Meeting: 2/18/2026
Applicant: Jesse Alarcon Onyx Excavation LLC
Owner: Sebastian Ferrara Jr.
District: Oakwood/Lincoln Park Infill Housing Overlay District

Location: 209 Chickamauga Ave. **Parcel ID:** 81 B G 038
Zoning: RN-2 (Single-Family Residential Neighborhood)
Description: New primary structure

Staff recommends postponement of Certificate 2-D-26-IH to allow the applicant to differentiate between the two identical duplexes and reduce the foundation height as possible.

2-D-26-IH
APPLICATION FOR CERTIFICATE OF APPROPRIATENESS

Site Plan of
 209 Chickamauga Ave
 for

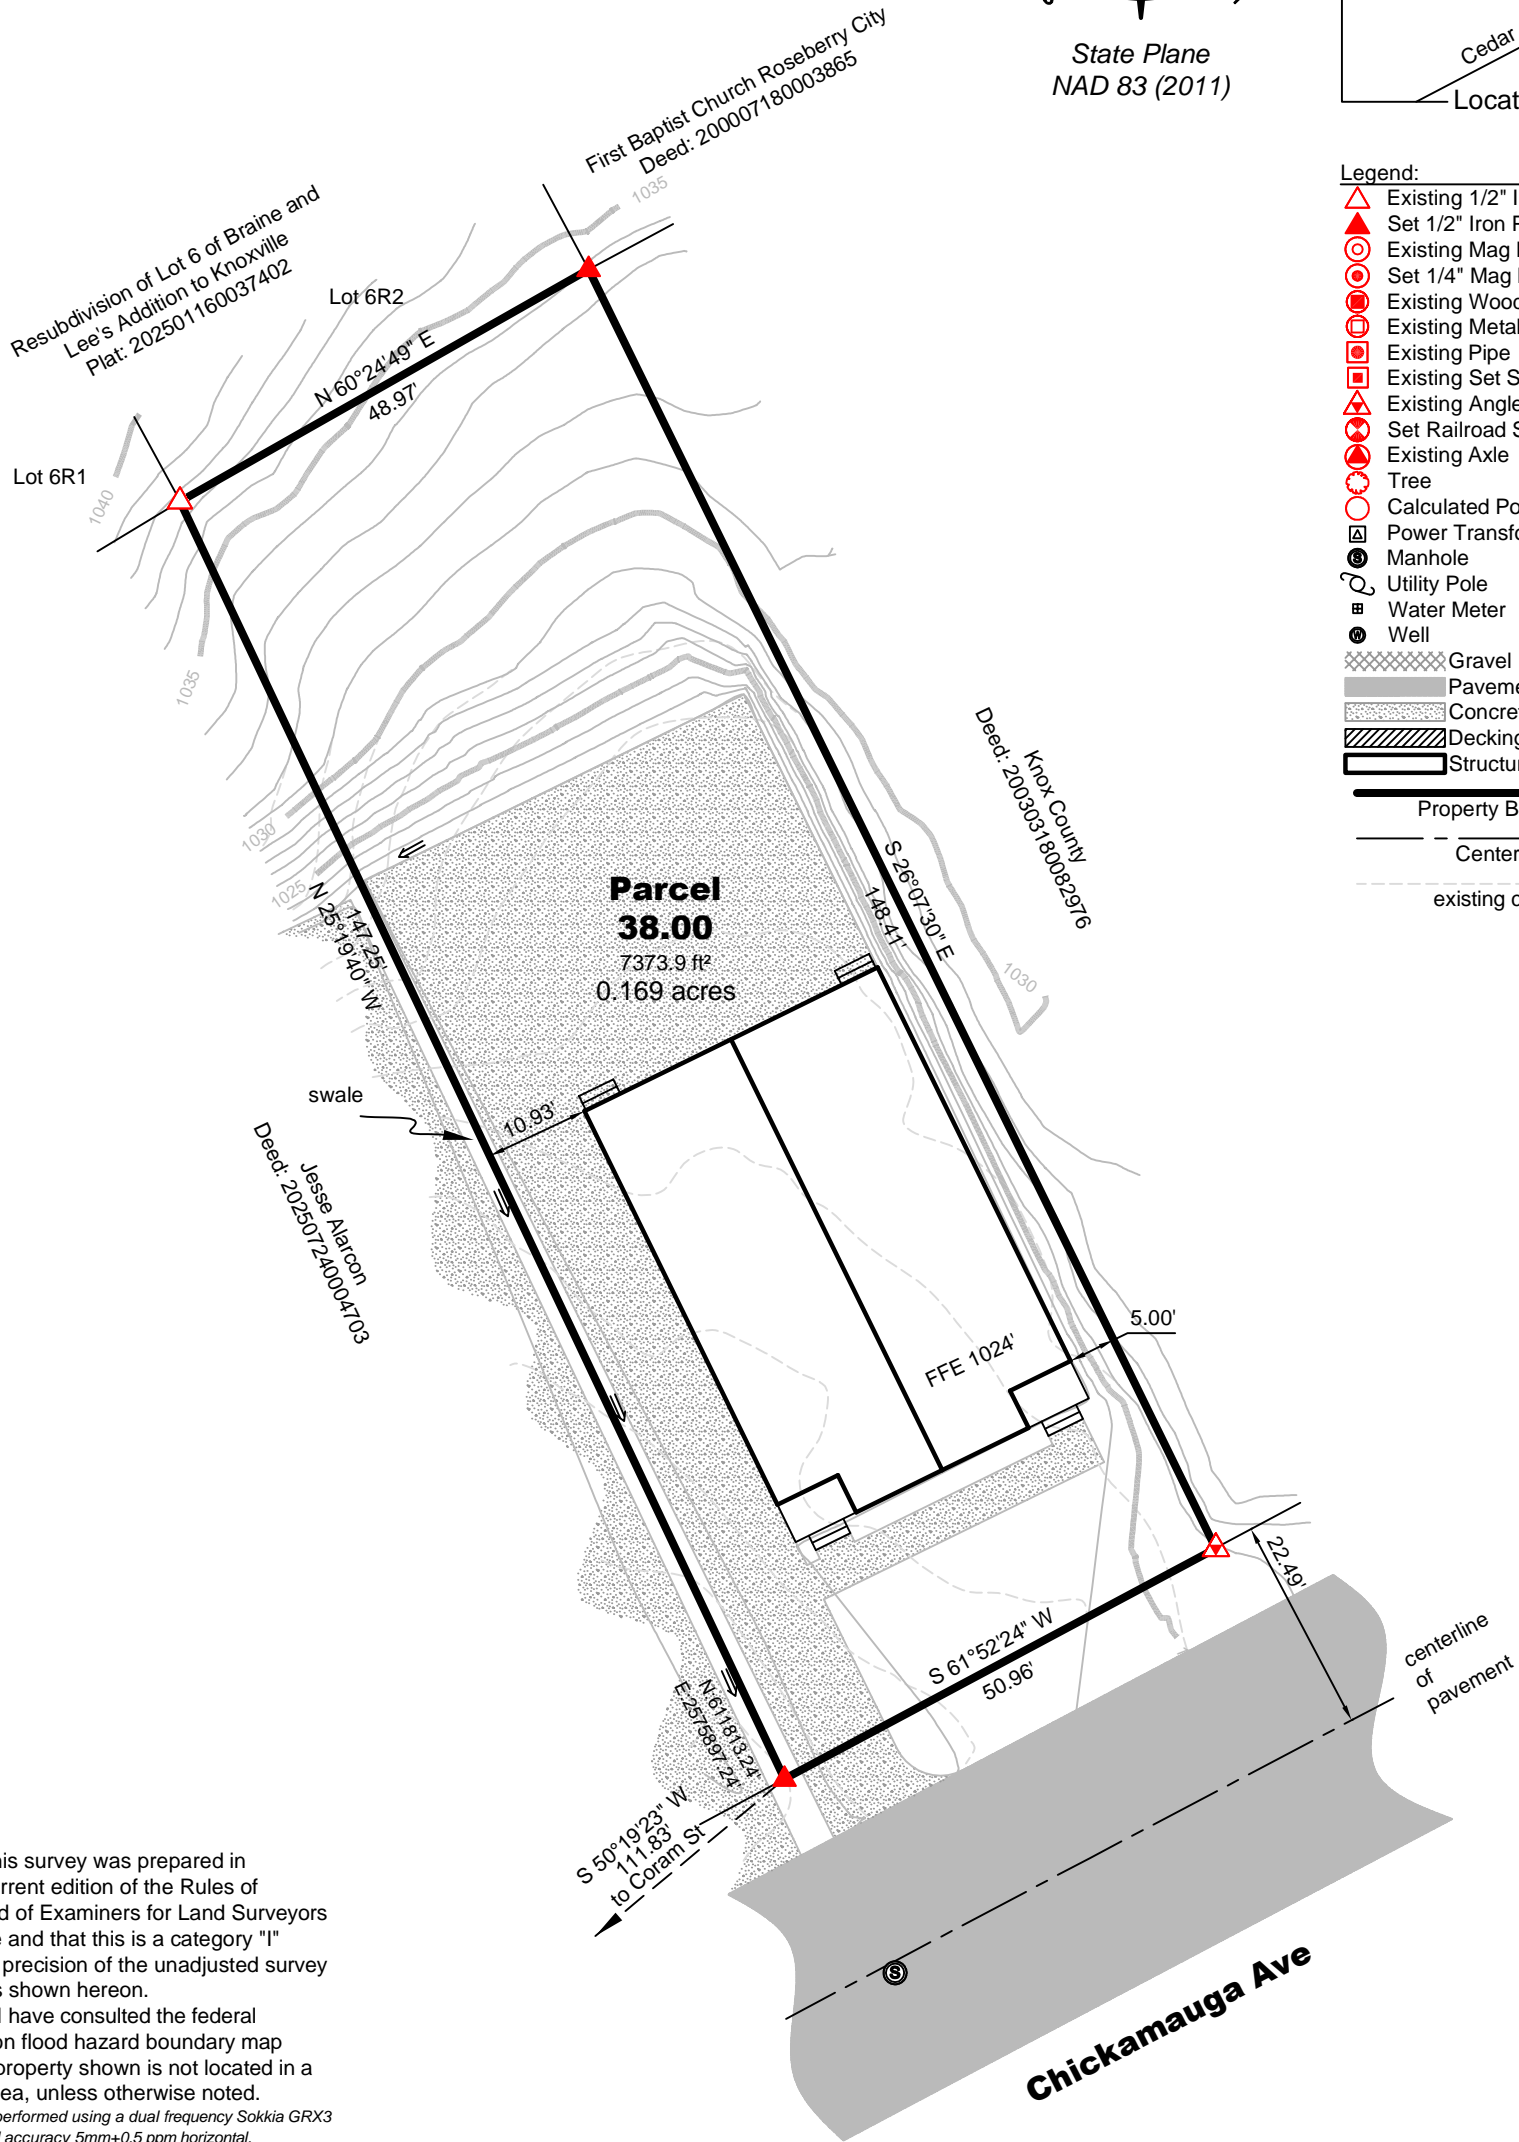
Front Yards: The front setback should be added to the site plan and will need to be between 24.4' and 34.4' to meet Middle Housing standards. The walkway should be revised to connect with the street.

Alleys, Parking, and Services: The final site plan should include the dimensions of the rear parking pad, which is large in scale.

Landscape: The final site plan should include at least one native or naturalized shade tree in the front and rear yards.

FRONT ELEVATION
UNIT "A" UNIT "B" 1/4" = 1'-0"

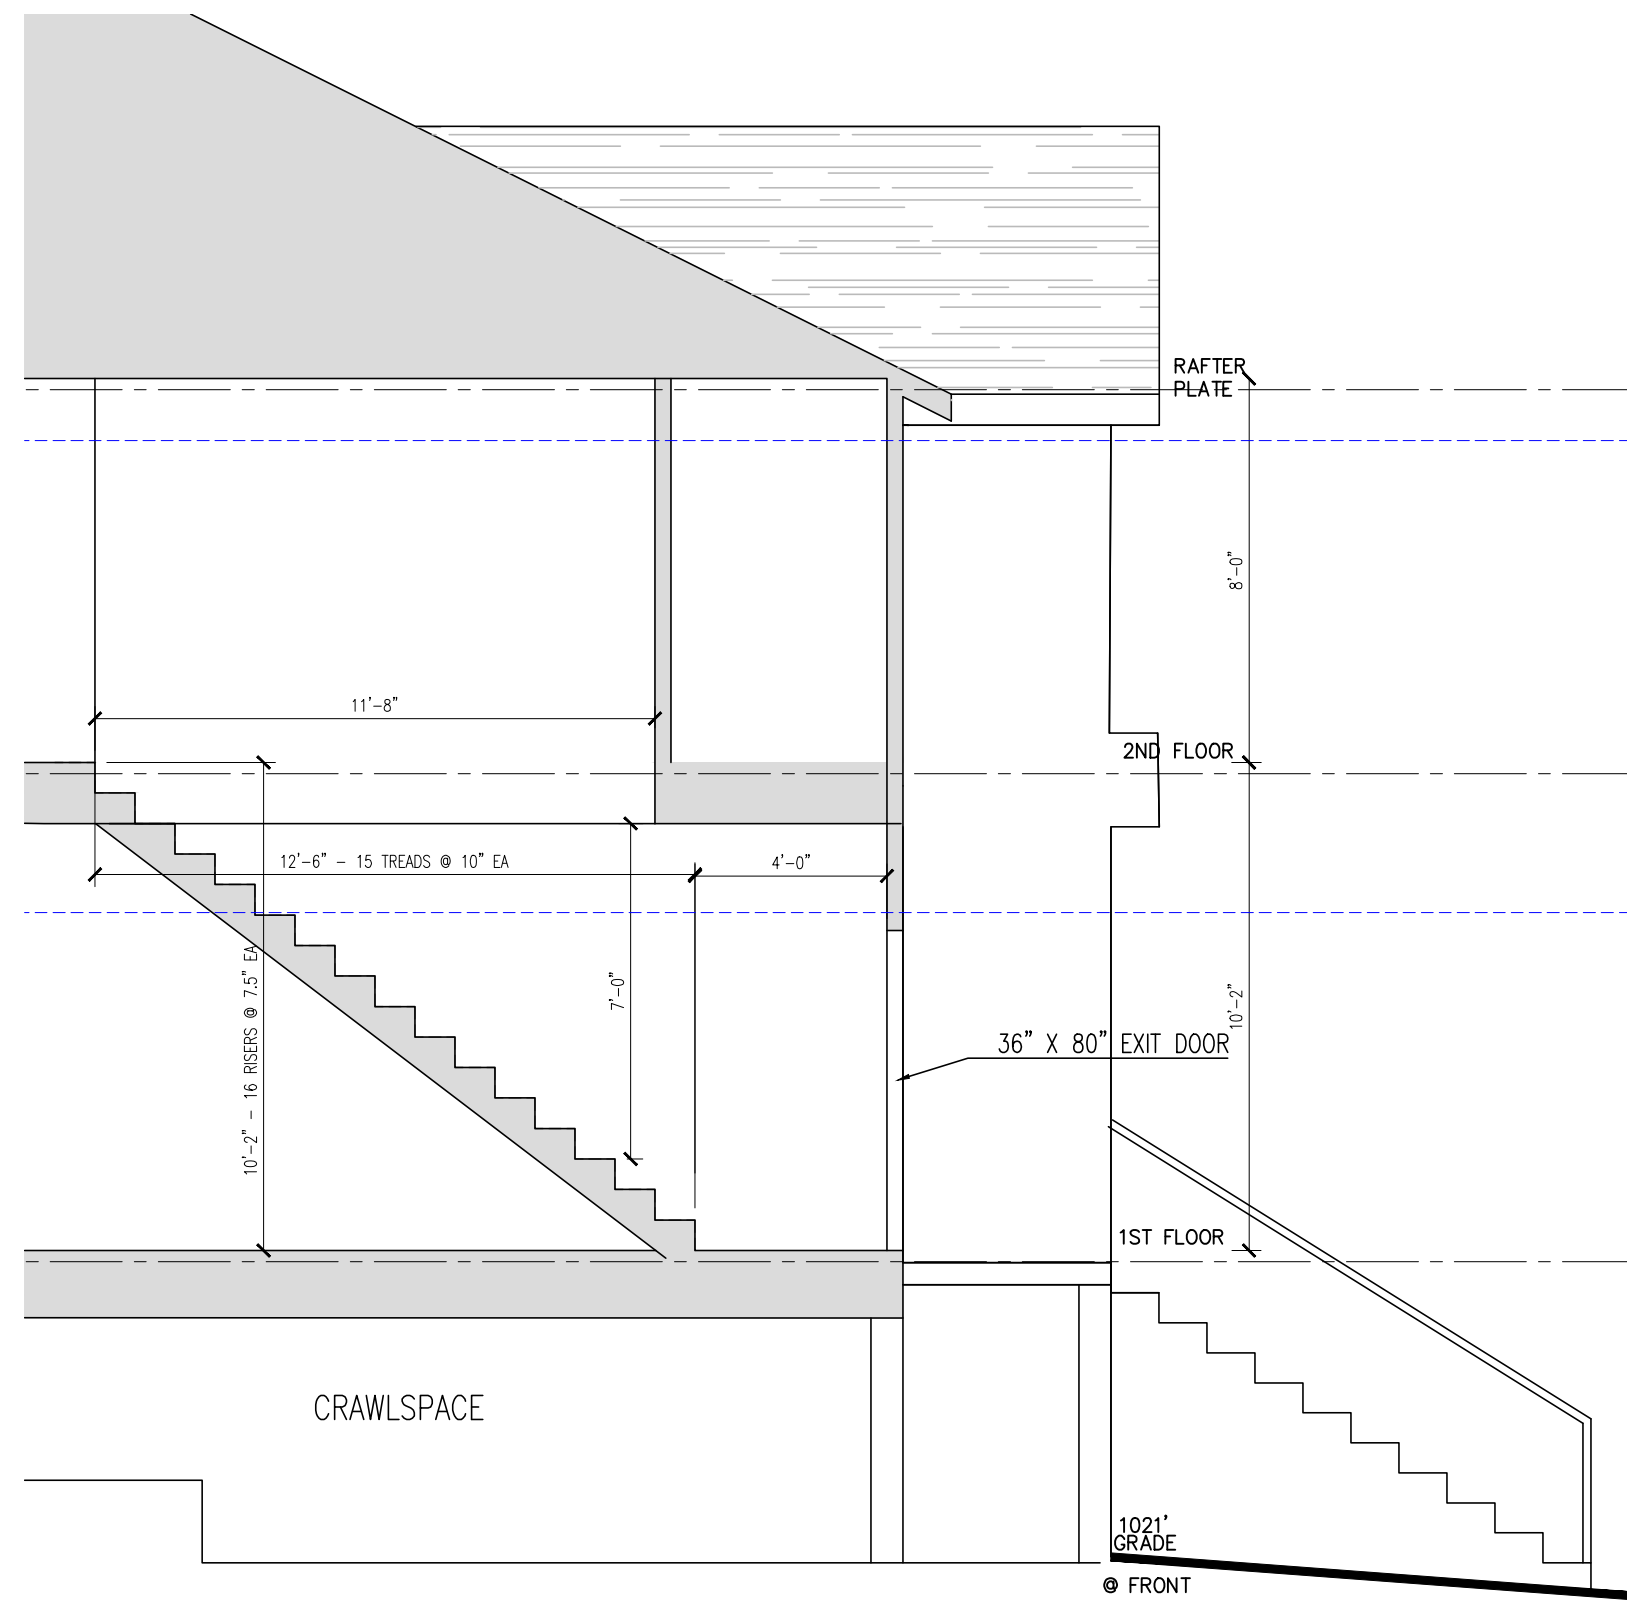
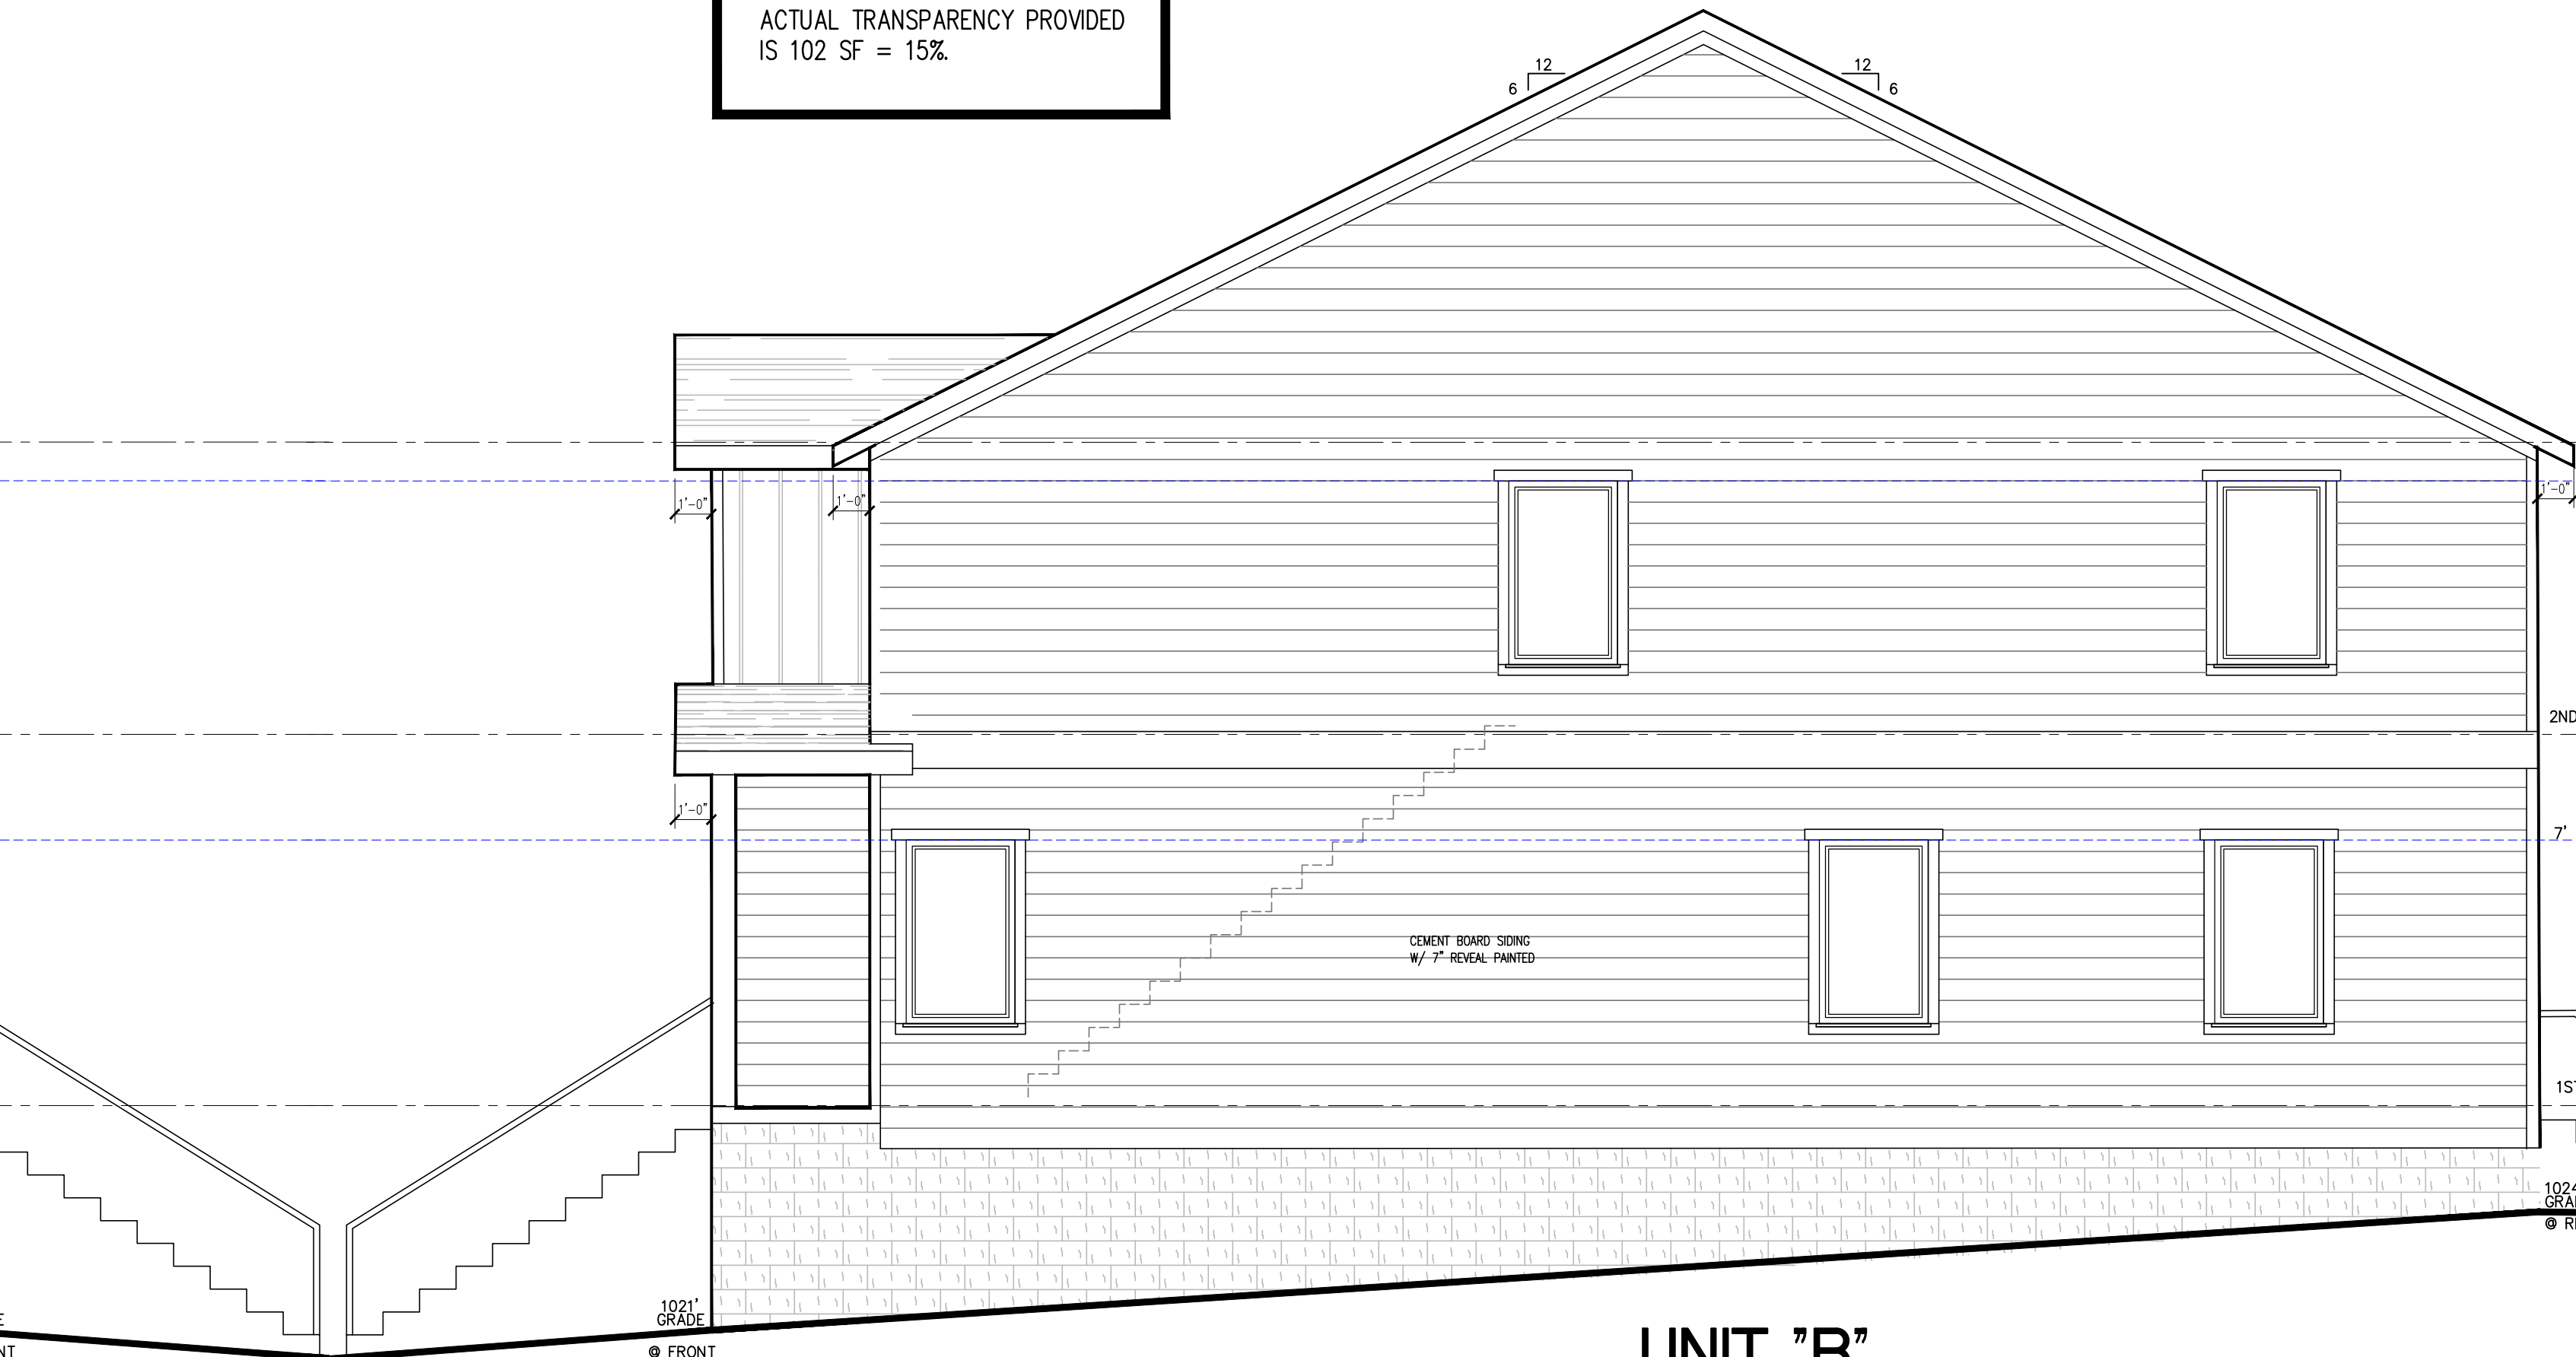
House Orientation and Side Yards: The 50' deep building is deeper than most buildings on the block, and the side elevations are large in scale. A recessed or projecting feature will need to be added to both side elevations to meet Middle Housing standards.

Scale, Mass, and Foundation Height: The block is characterized by one-story Minimal Traditionals, modified Queen Anne cottages, with one two-story townhouse building. The visual scale of the two-story building is increased by the 5' tall foundation height. The foundation height should be reduced, if at all possible, and the foundation should be parge-coated, clad in stucco, or clad in brick veneer.

Porches and Stoops: The porches are small in scale but are similar to others than have been approved on multifamily buildings within the overlay. The porch posts should be at least 6" by 6".

Windows and Doors: The operation type of the windows should be clarified, which should be single-hung, double-hung, or casement.

Multi-Unit Housing: The design does not incorporate contextual architecture features, as recommended by the design guidelines. The applicant is proposing an identical duplex on the adjacent western property. Methods should be taken to differentiate the two buildings, which should include revisions to the roofline on the façade among other interventions.
